The Commission has issued the enclosed Amendment No. 3 to Facility License No. DPR-35. This amendment includes Change No. 5 to the Technical Specifications, Appendix A, and is in response to your requests dated October 16, 1973, February 15, 1974, and March 4, 1974.

Amendment No. 3
License No. DPR-35

ATTACHMENT TO LICENSE AMENDMENT NO. 3
CHANGE NO. 5 TO TECHNICAL SPECIFICATIONS (APPENDIX A)
FACILITY OPERATING LICENSE NO. DPR-35

SAFETY EVALUATION BY THE DIRECTORATE OF LICENSING
SUPPORTING AMENDMENT NO. 3 TO LICENSE NO. DPR-35
(CHANGE NO. 5 TO APPENDIX A OF TECHNICAL SPECIFICATIONS)

FIGURE 3.4.1
SODIUM PENTABORATE SOLUTION
VOLUME AND CONCENTRATION
REQUIREMENTS

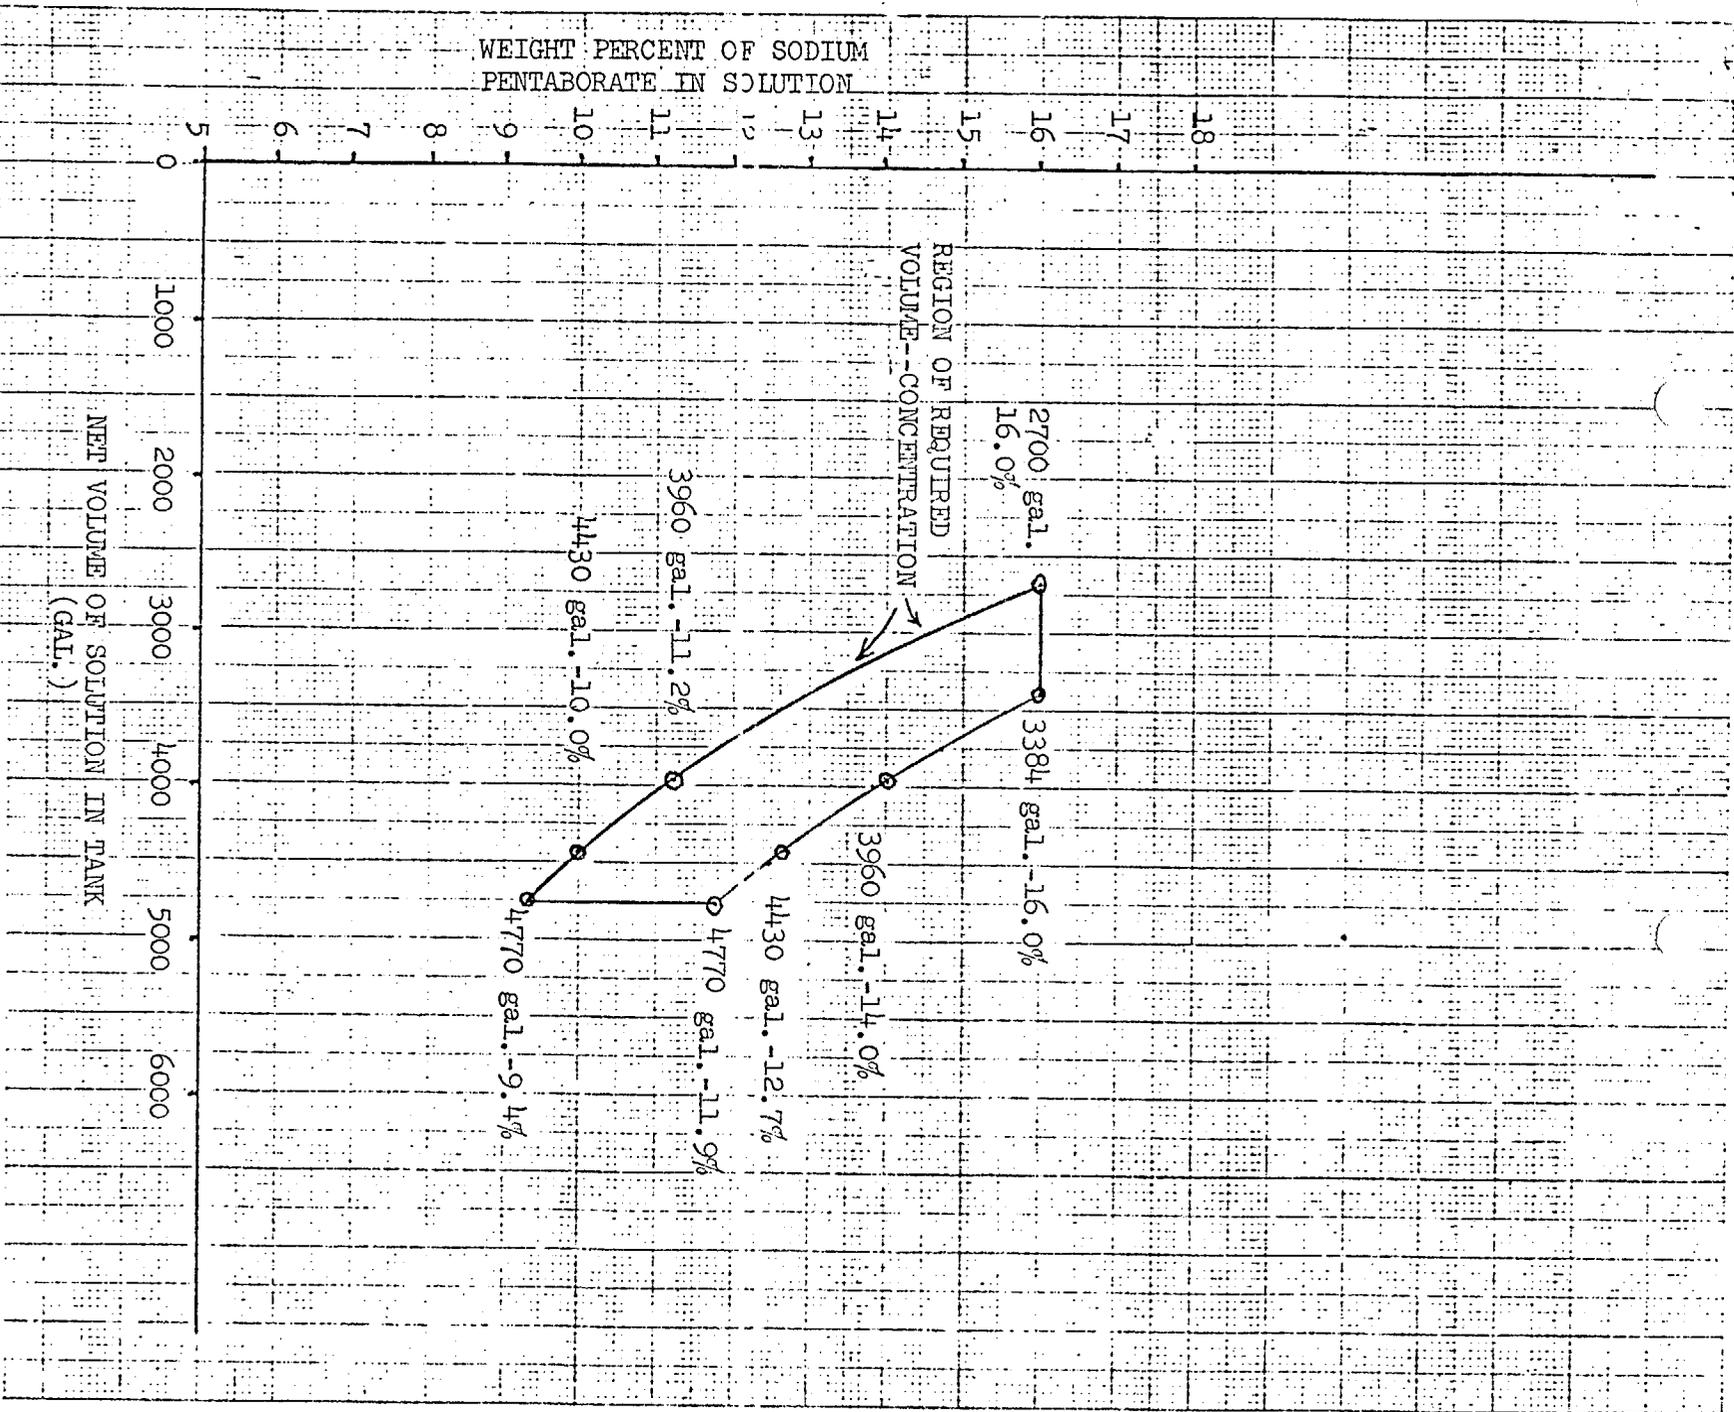
Additionally, the effectiveness of the liquid poison injected by the standby liquid control system has been lessened by core changes associated with cycle 2 operation. Boston Edison will increase the sodium pentaborate solution concentration to maintain the 5% $\Delta K/k$ shutdown margin used as the design basis for this system.

This change increases the required boron concentration for the standby liquid poison system to assure that the design criteria of 5% $\Delta K/k$ shutdown margin is maintained. This change maintains the margin of reactor safety and is therefore acceptable.

A minimum quantity of 2700 gal. of solution having a 16.0 percent sodium pentaborate concentration is required to meet this shutdown requirement. For the minimum required pumping rate of 39 gpm, the maximum net storage volume of the boron solution is established as 4770 gal.

FIGURE 3.4.2
TEMPERATURE REQUIREMENTS OF THE SODIUM PENTABORATE SOLUTION

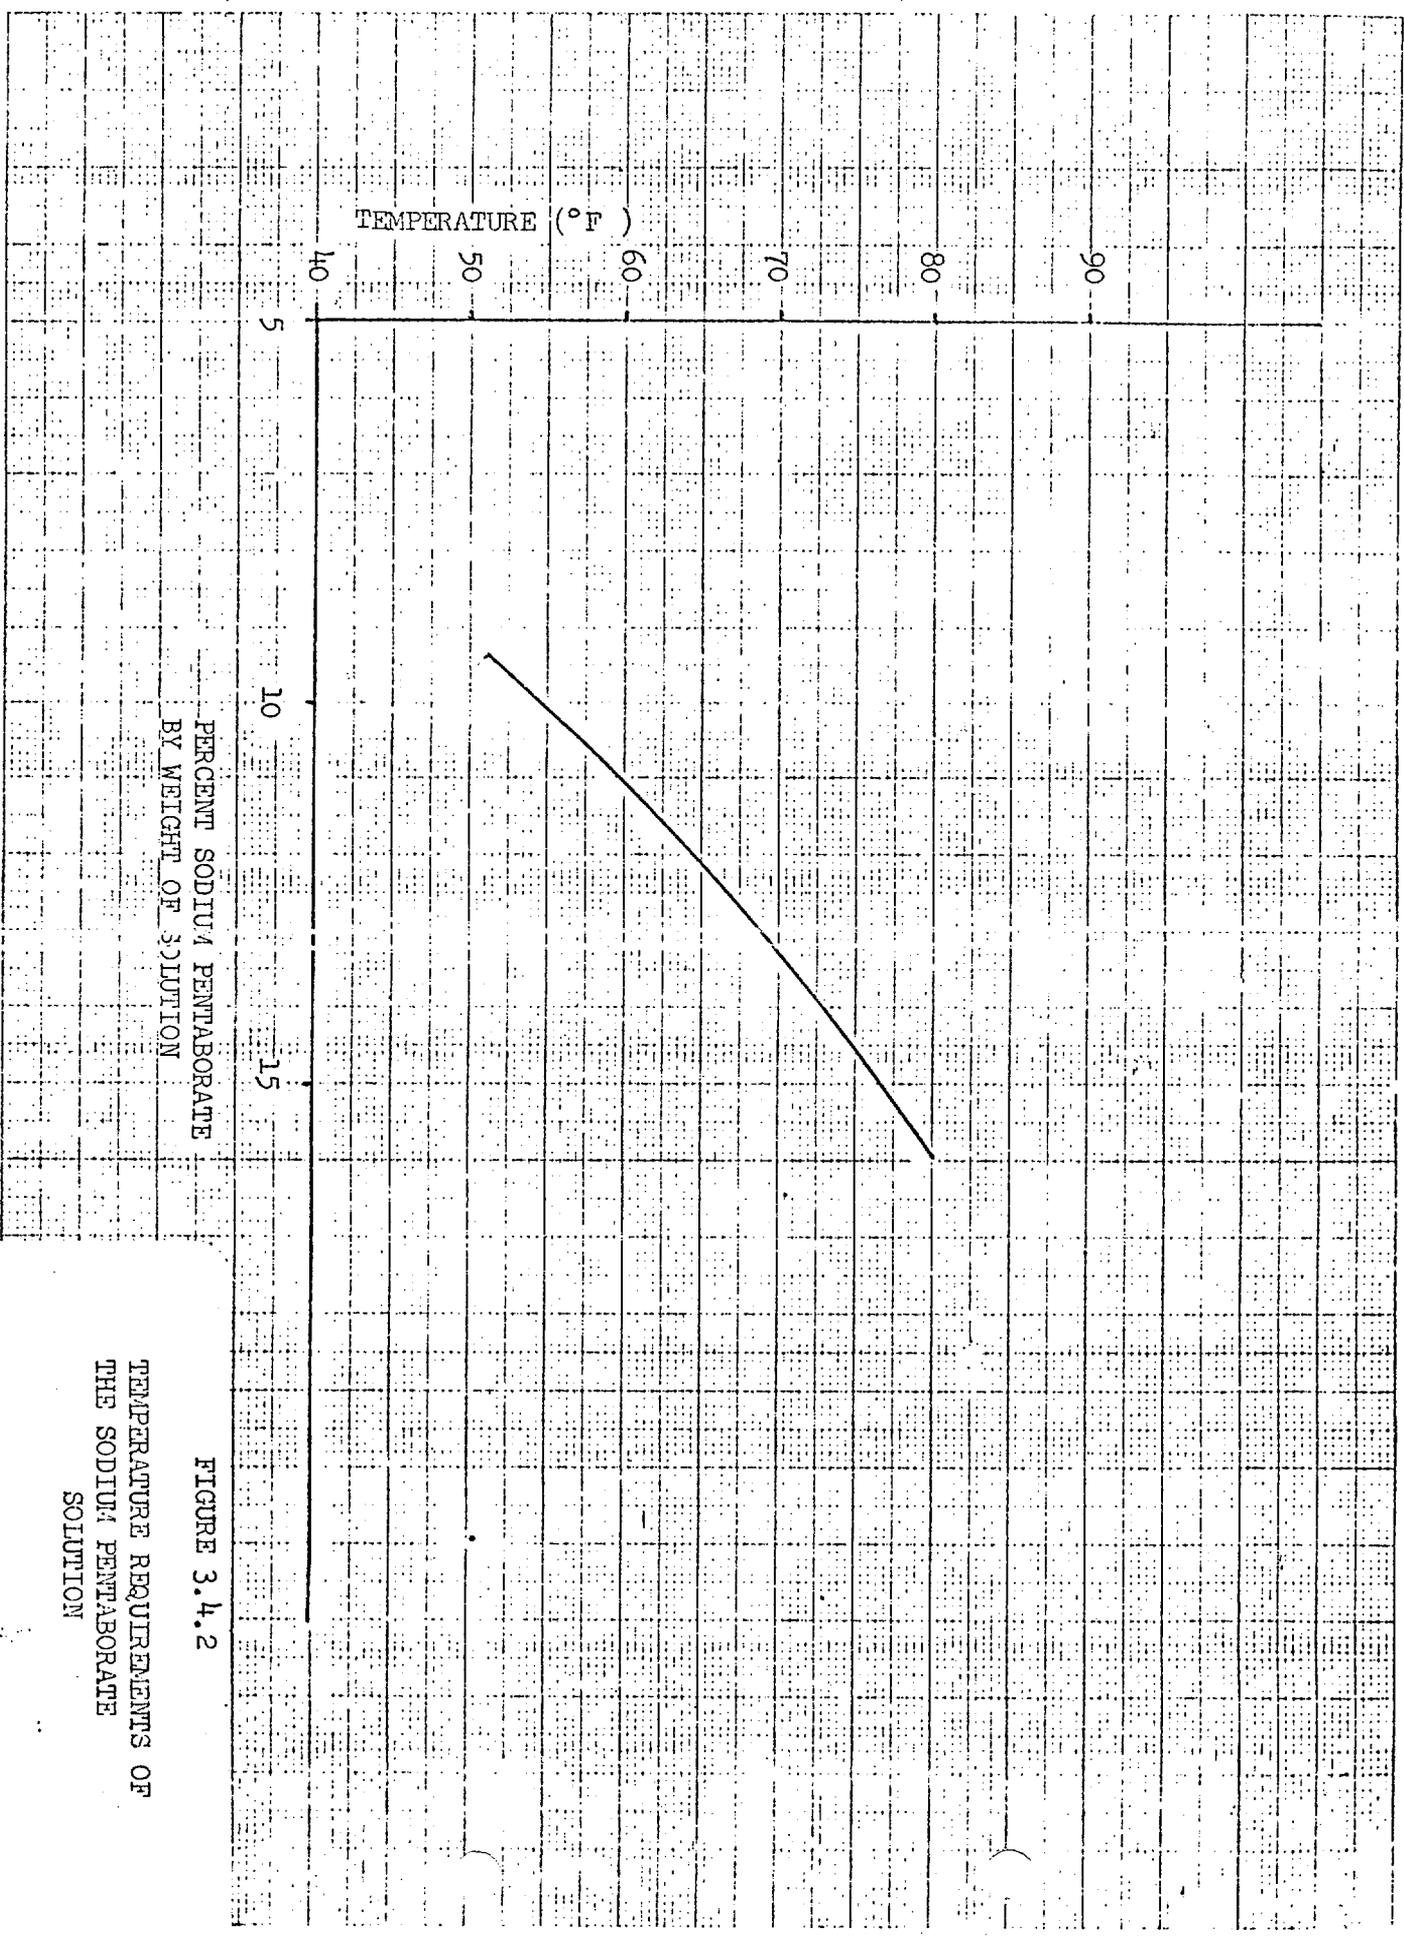
The solution is kept at least 10°F above the saturation temperature to guard against boron precipitation. The margin is included in Figure 3.4.2.
